# Croydon Kowloon Designs Ltd. (Unit-2)

2 December 2025

## Structural Inspection Report

**Observation-02:** Construction safety practice for the factory premises. (Production Building and Utility Building)

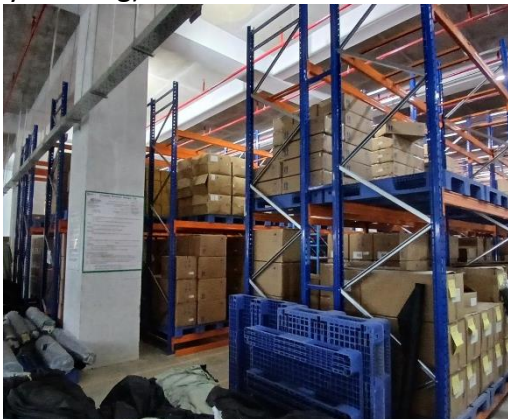
**Description:** Lack of construction safety practices observed in the Production & Utility Building. The building engineer is required to follow all the standard construction safety practices according to BNBC 2020, Part 7, Chapter 3.

| Item No | Observation                                                                | Action Plan                                                                                                                                                                     | Timeline        |
|---------|----------------------------------------------------------------------------|---------------------------------------------------------------------------------------------------------------------------------------------------------------------------------|-----------------|
| 4.      | Lack of standard construction safety practice in Production Building       | The building engineer is required to ensure the health & safety of the workers and follow the standard construction safety practices according to BNBC 2020, Part 7, Chapter 3. | Immediate       |
| 11.     | Lack of standard construction safety practice in Utility Building          | The building engineer is required to ensure the health & safety of the workers and follow the standard construction safety practices according to BNBC 2020, Part 7, Chapter 3. | Immediate       |
